FINAL PLAT
HARDY ROAD PROPERTIES
A PORTION OF THE SOUTHWEST QUARTER
SEC. 14, T11S, R65W OF THE 6TH P.M., COUNTY OF EL PASO, STATE OF COLORADO
PCD Number: SF265

Project No.: 26009
June 1, 2026
Sheet 1 of 2

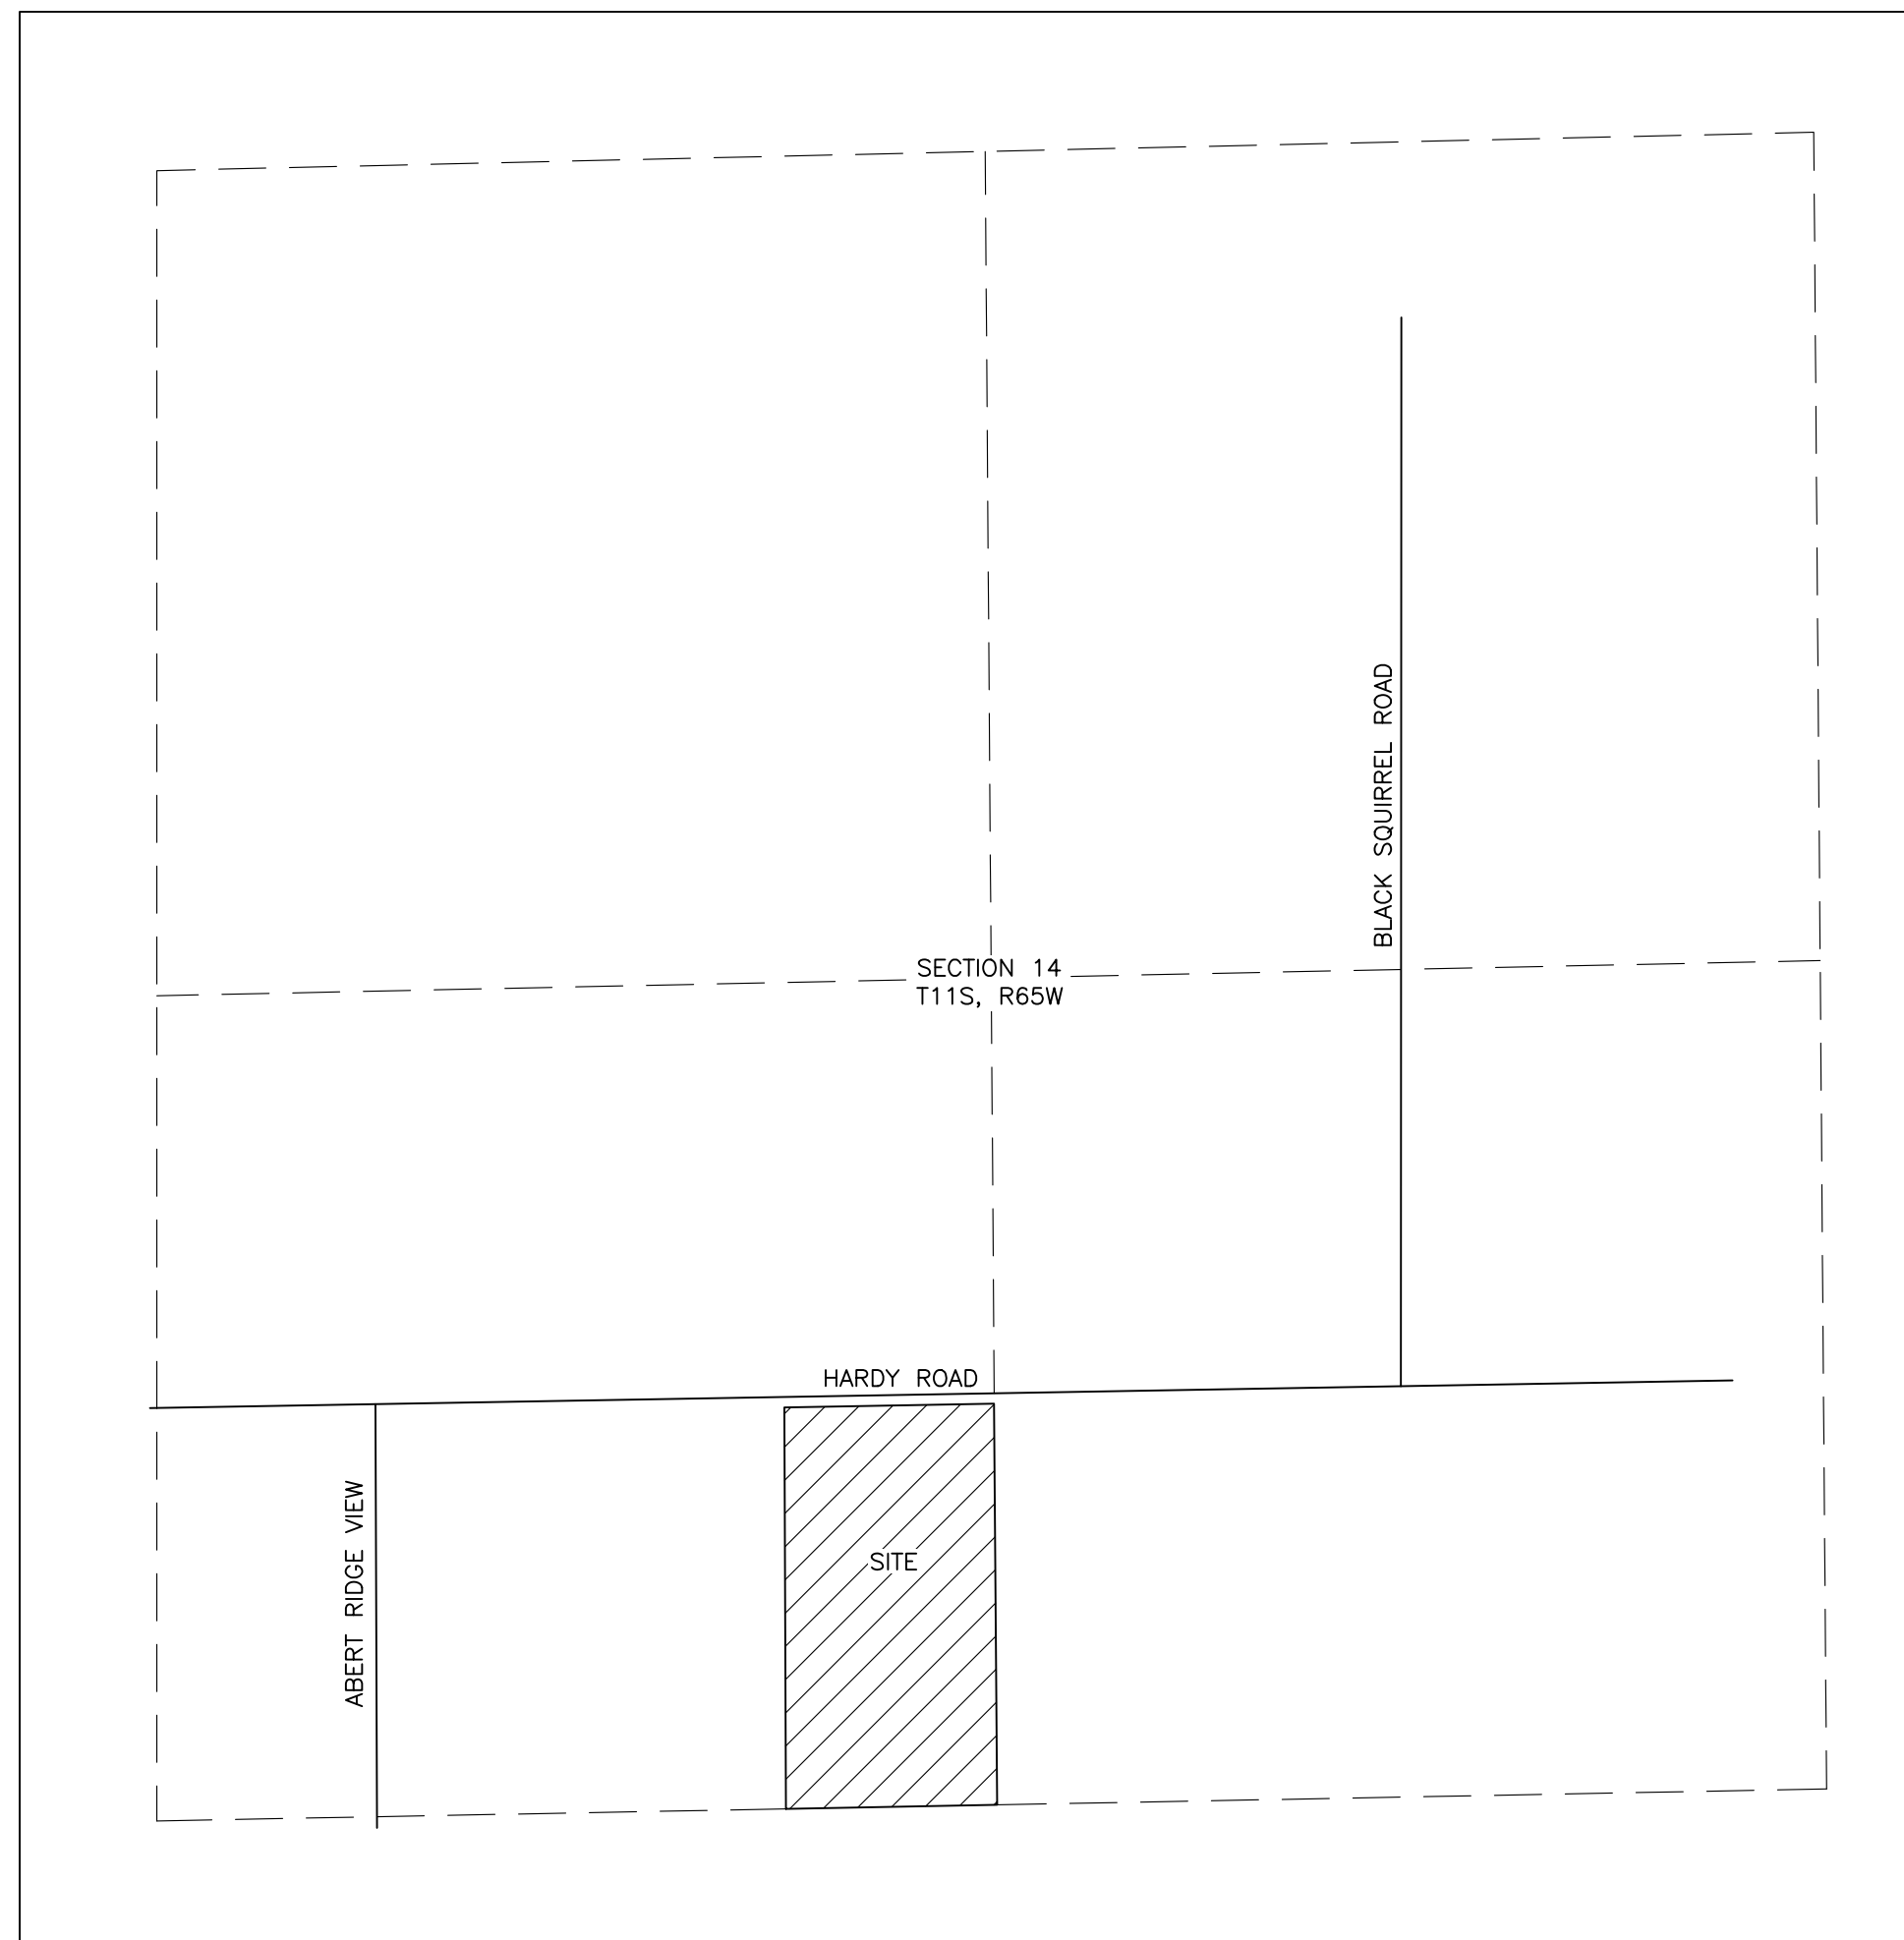
I acknowledge that there was a good attempt to address all the comments but you did miss some of the important text details. Please add the two notes below and place them where the arrow is pointing.

1. RMG (page 13), "Shallow groundwater is anticipated to impact the proposed development in the location of the test borings and test pits," and recommends (for homes located south of the existing homes to the east and west as follows:

- "A yearlong groundwater monitoring program be implemented to verify the separation of groundwater through all four seasons.
- Restrict basement construction.
- Raise the foundation bearing elevation to maintain separation."

Since groundwater was encountered as shallow as 5 feet below grade, CGS recommends that the county require groundwater monitoring/observation to obtain data to determine the feasibility of basements and to verify that proposed foundation components are at least 3 feet above the maximum anticipated groundwater level and are maintained year-round. To be effective, however, this monitoring should include observations through spring, summer, fall, and winter, and not merely during site-specific building investigations. CGS recommends that basements are not allowed at this location unless a groundwater monitoring program is performed.

2. Prior to building permit application, site-specific soils and foundation investigations for the proposed structure(s).

DRAINAGE EASEMENT DETAIL
SCALE: 1"=80'

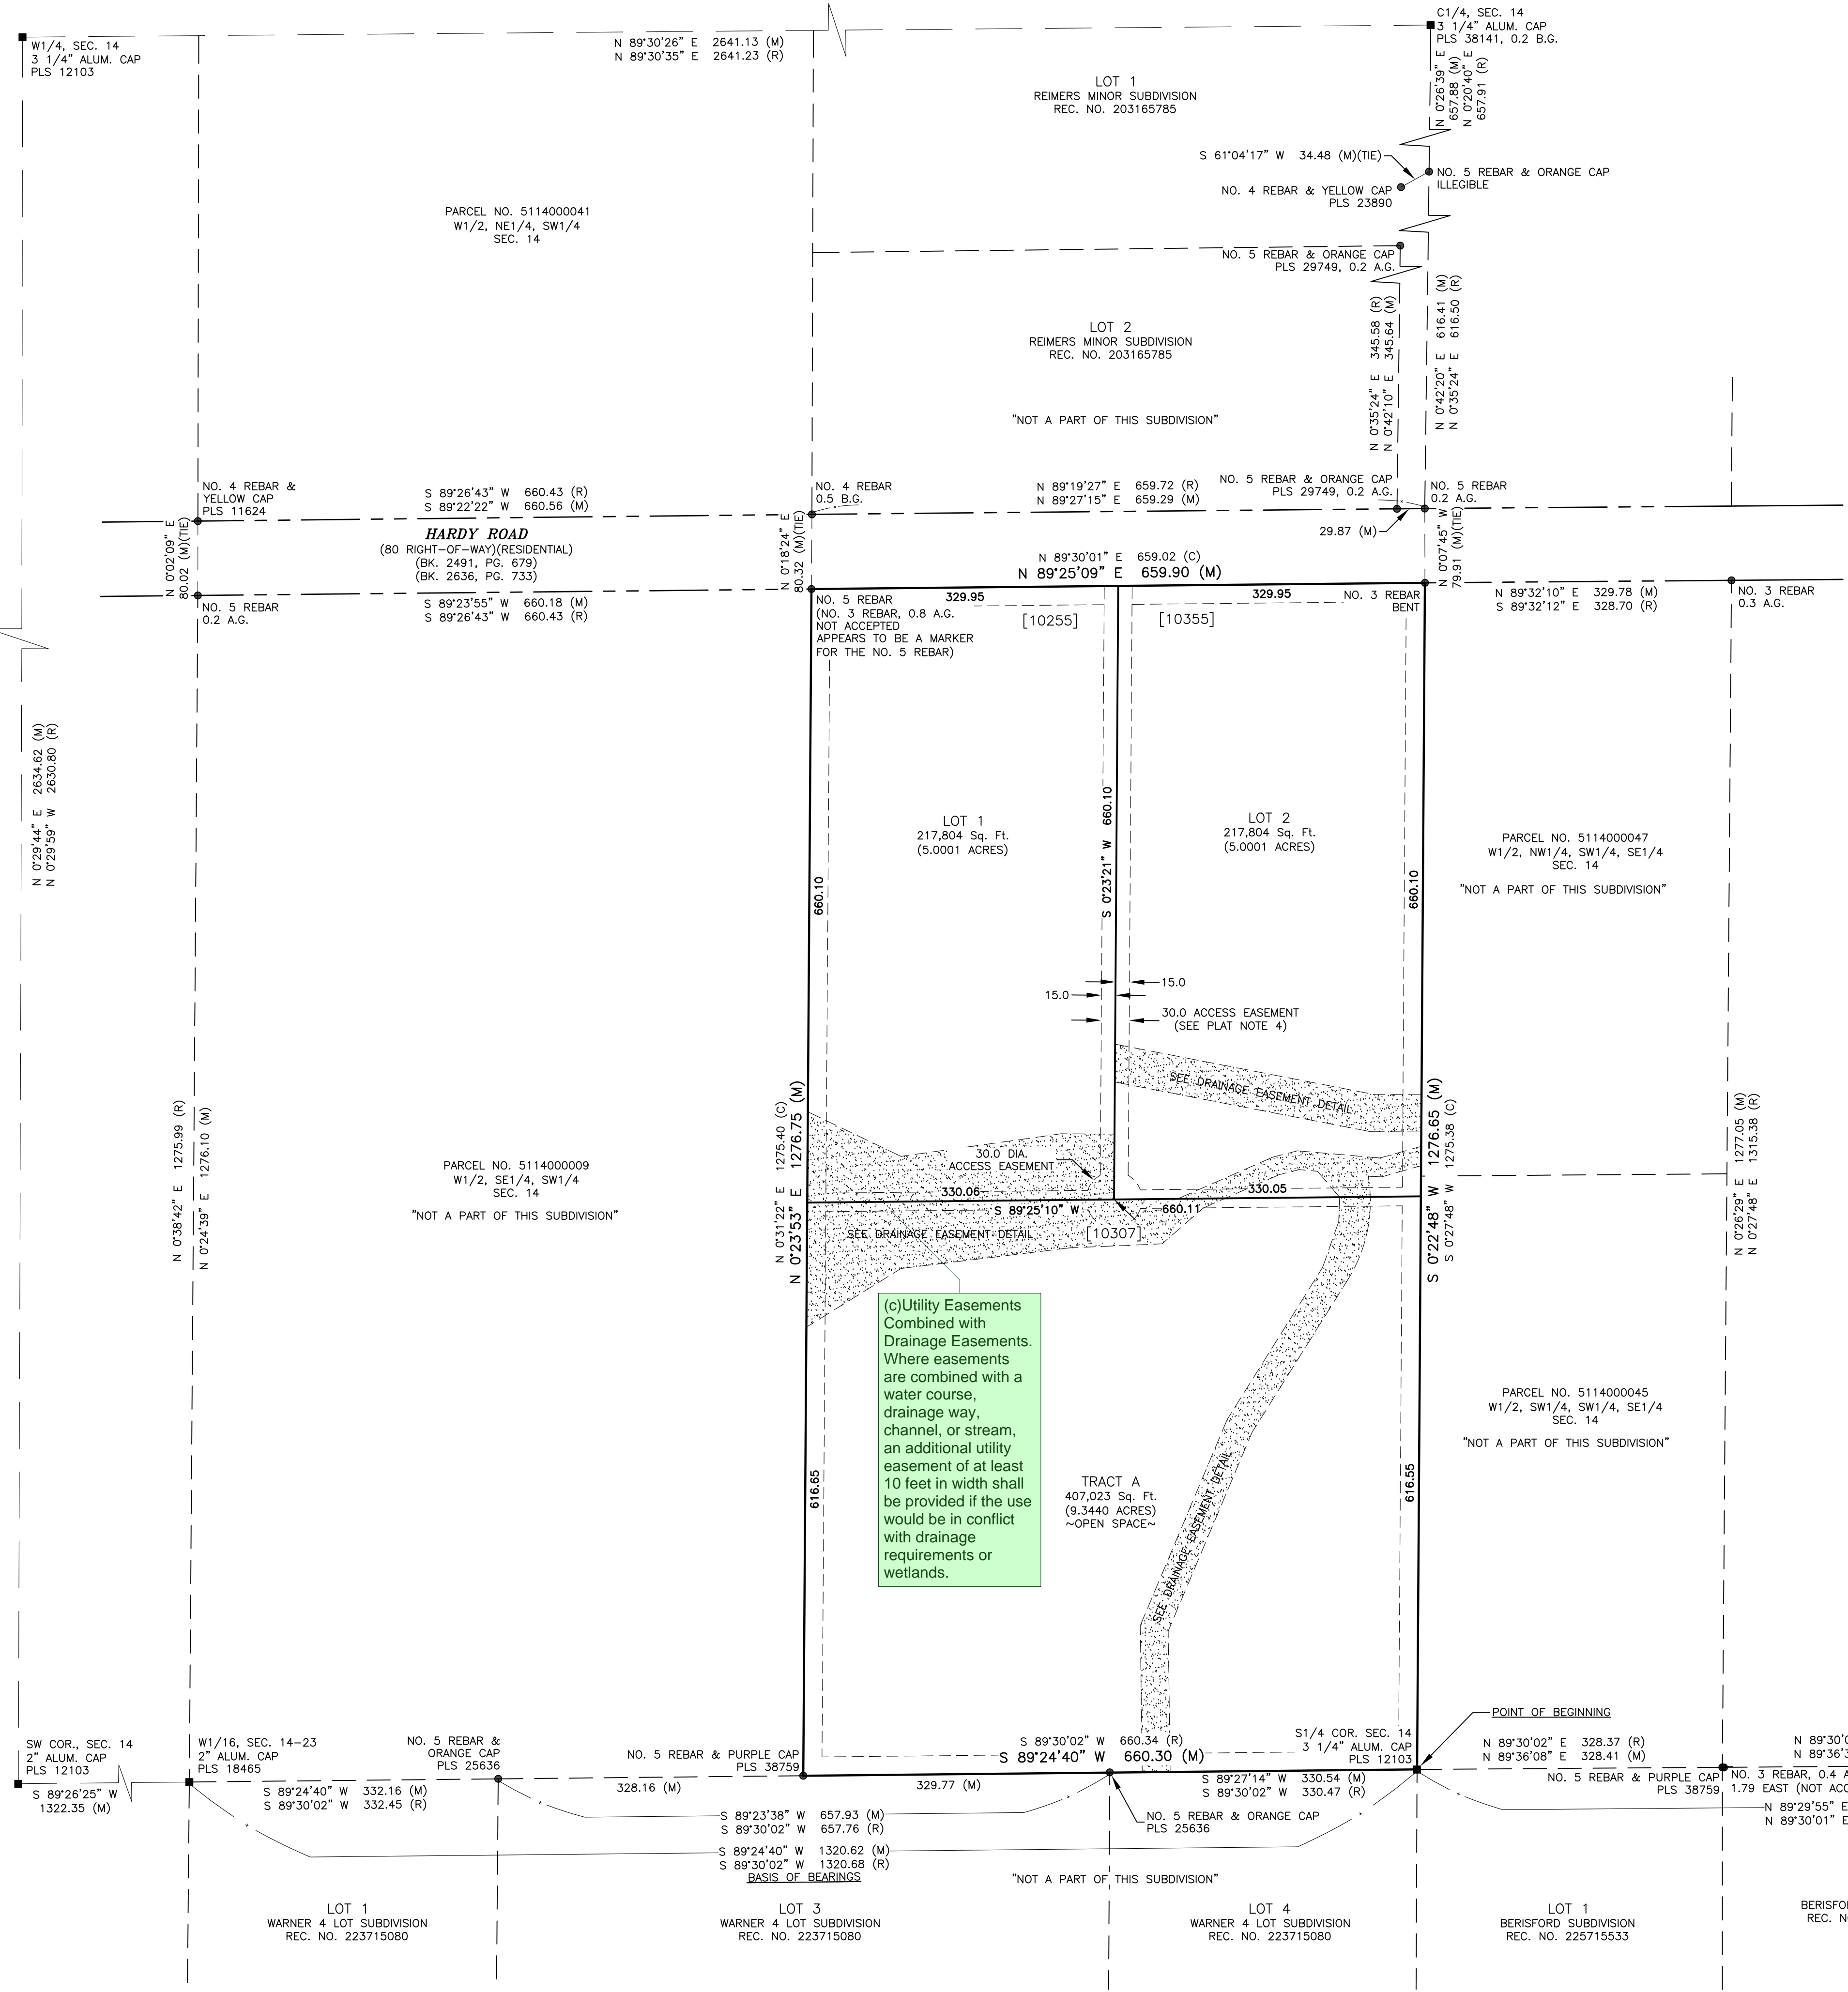
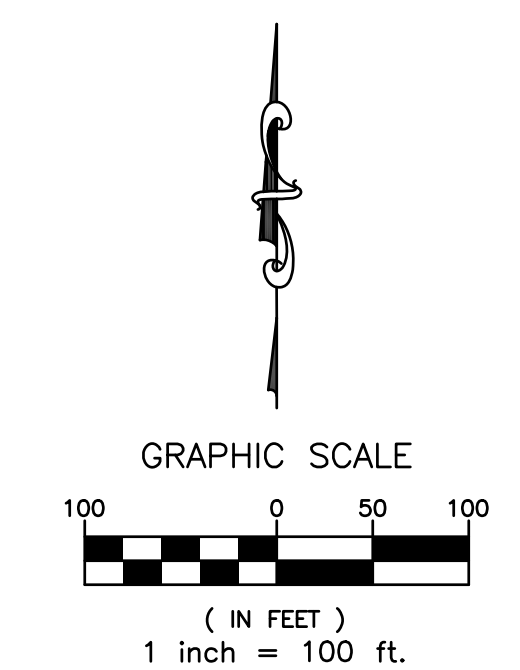
(c) Utility Easements Combined with Drainage Easements. Where easements are combined with a water course, drainage way, channel, or stream, an additional utility easement of at least 10 feet in width shall be provided if the use would be in conflict with drainage requirements or wetlands.
